37/03-05WW 7420 Cedar Ave Takoma Park Historic District

Historic Area Work Permit # 393745

#### **HISTORIC PRESERVATION COMMISSION STAFF REPORT**

**PROPOSAL:** Front porch alterations

vertical Screen Francing 4"x6"

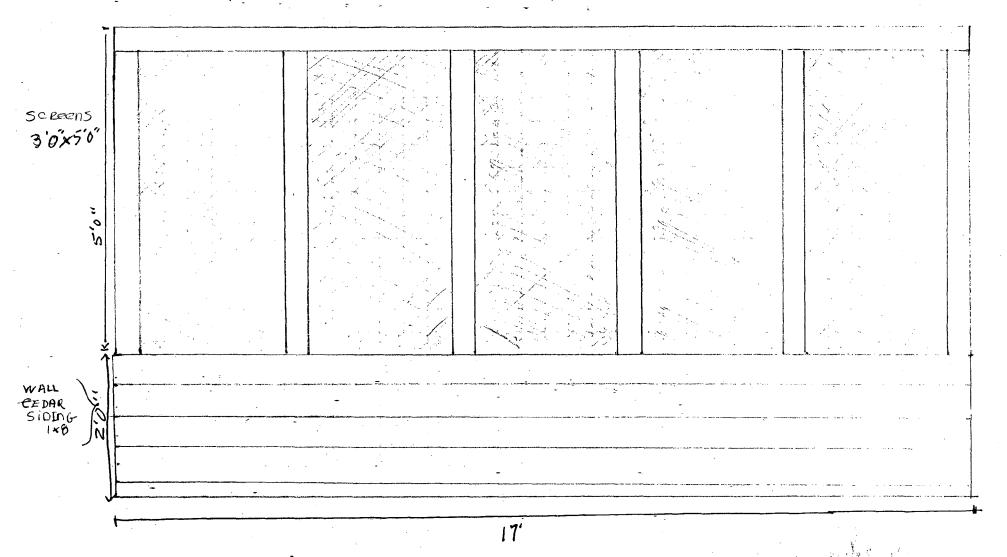
APPROVED

9-15
